PCD FILE NO. PPR-21-024

STANDARD NOTES FOR EL PASO COUNTY GRADING AND EROSION CONTROL PLANS

DRAWN BY: O.E. WATTS	APPROVED BY:	REVISIONS 3-16-21 REVISED BUILDINGS DEW	PROJECT 10659 MALTESE POINT LOT 11, ROLLING THUNDER BUSINESS PARK EL PASO COUNTY	SHT. NO. 2 OF 2
DATE: 4-2-21	PROJ. NO.	9-27-21 REVISED PER COUNTY REVIEW COMMENTS DEW		
DWG. NO.: 20-5509-07	DWG.	12-30-21 REVISED PER COUNTY REVIEW COMMENTS DEW		
SURVEYED BY: DEW, ESW, 6-26-19, 9-24-20				
OLIVER E. WATTS CONSULTING ENGINEER COLORADO SPRINGS			GRADING AND EROSION CONTROL PLAN

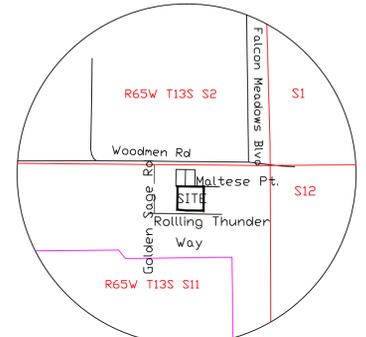
GEC Checklist Item p. the limits of cut and the limits of fill should be delineated for each, not the site limits for both combined. While the limits of disturbance can be the limit of fill, you are cutting at the pond area. Please show the limits of cut and the limits of fill and delineate between the two. Please call if you have any questions regarding this comment prior to resubmittal

How will the stormwater be diverted to the TSB and ultimately the SFB? The interim condition should have a diversion ditch directing the flow to the TSB. The final condition originally had two inlets and storm piping to the SFB, without this piping, its not clear how the stormwater will be directed to the SFB once the asphalt is installed. Please call if you have any questions regarding this comment prior to resubmittal

include inlet protection (interim) Unresolved

show pond details -- outlet structure, spill way, underdrain, etc. unresolved.

would you mind changing these to initial/interim? i missed it on the last review.

It appears that there may be a conflict with the proposed retaining wall and existing manhole and storm pipes. Please provide a detail/cross section showing how this will work or correct linework

The interim condition should have a diversion ditch to direct the stormwater to the TSB before the curb is installed. Please call if you have any questions regarding this comment prior to resubmittal

adjust page numbers unresolved.

Please update page # 1-4

FIGURE SF-1 SAND FILTER PLAN, PROFILE AND SECTION

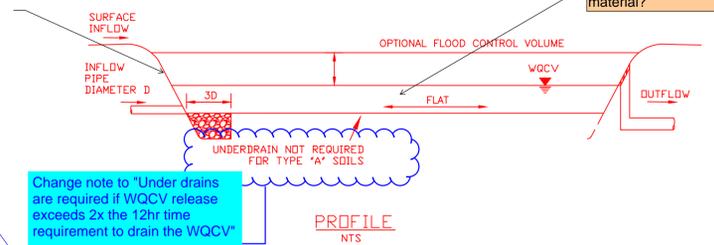
Change note to "Under drains are required if WQCV release exceeds 2x the 12hr time requirement to drain the WQCV"
 Underdrains are part of the SFB standard design per DCM Vol. 2

TEMPORARY SILTATION BASIN

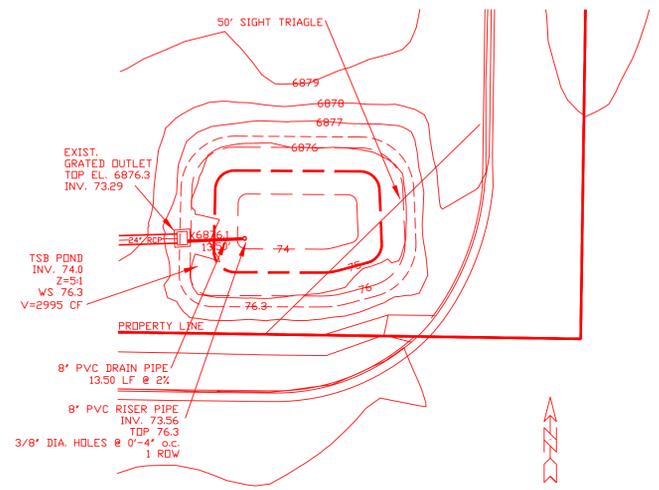
Please add a note stating that an on-site infiltration test using double-ring infiltrometer is required. Infiltration tests should be performed or supervised by a licensed professional engineer and conducted at a minimum depth equal to the bottom of the sand filter.

Not shown on plan view. Provide details of outlet structure, pipe size, inverts, material, etc.

not shown on plan set. provide detail with elevations, material, dimensions, etc.

Provide details -- material, depth of material?

Please delete floating text
